AIR STRUT - TOP PLATE

FIGURE 1

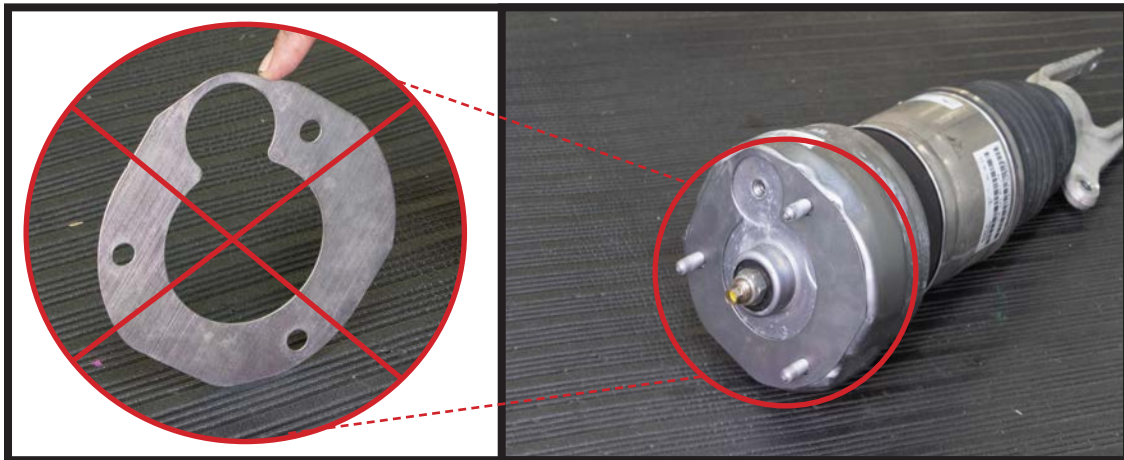
1. DO NOT REUSE FACTORY TOP SHIM. (FIGURE 1)

FIGURE 2

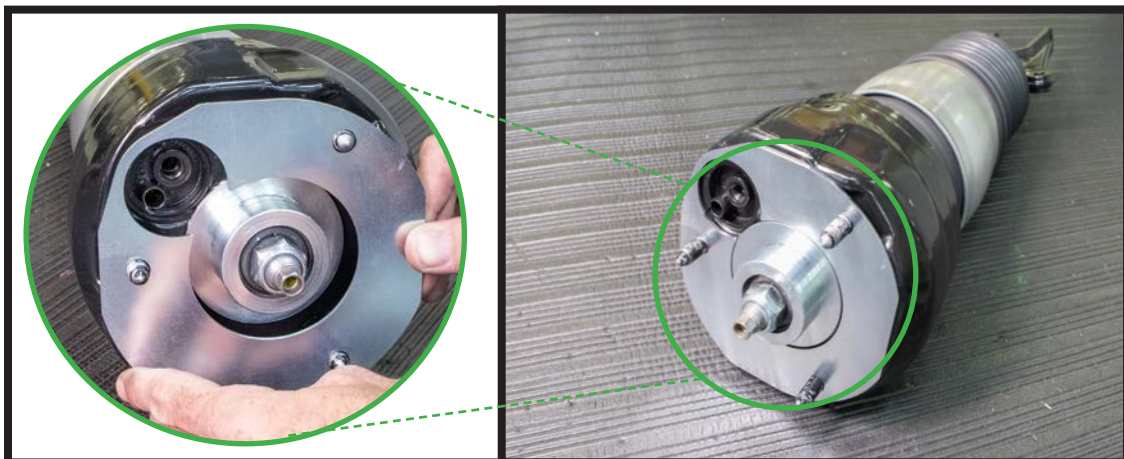
2. INSTALL THE SUPPLIED TOP SHIM, MAKING SURE IT IS PROPERLY ALIGNED. (FIGURE 2)
